Document Title: **Overland Maintenance Dredging – Main Channel, River Neath**

Authority: **Neath Port Authority**

Document Type: **Summary / Supporting Information – NRW Marine Licence Application**

Document Ref: **NPA-OLD-MC-01**

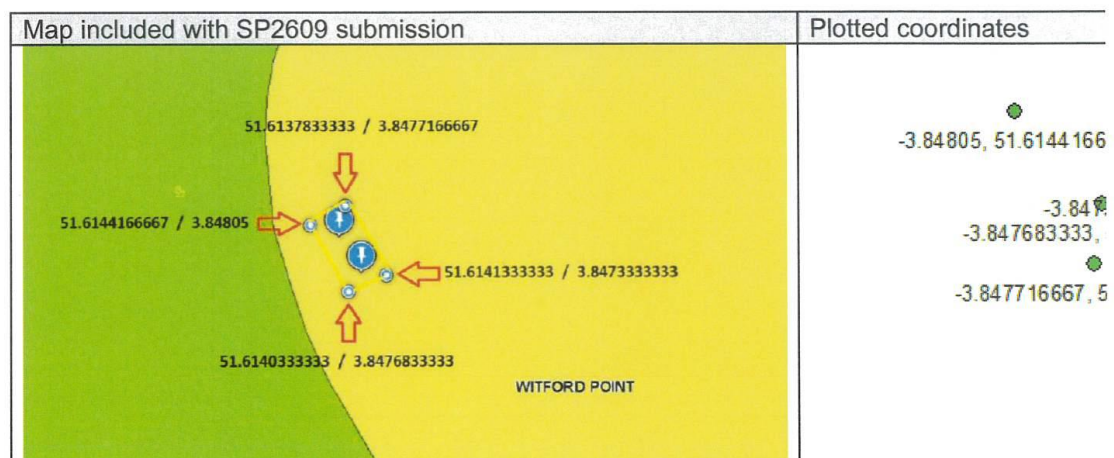
- The longitude coordinates provided for all sites are missing the "-" prefix, which denotes a westerly position. Please review and resubmit all coordinates with the appropriate correction.
- The coordinates submitted for the disposal area identified as "Inner Dune Area Disposal" do not define the same area shown on the map provided within the submission. A comparison between the submitted map and the plotted coordinates is provided below for reference:

Please review the coordinates for this location and resubmit the correct information.
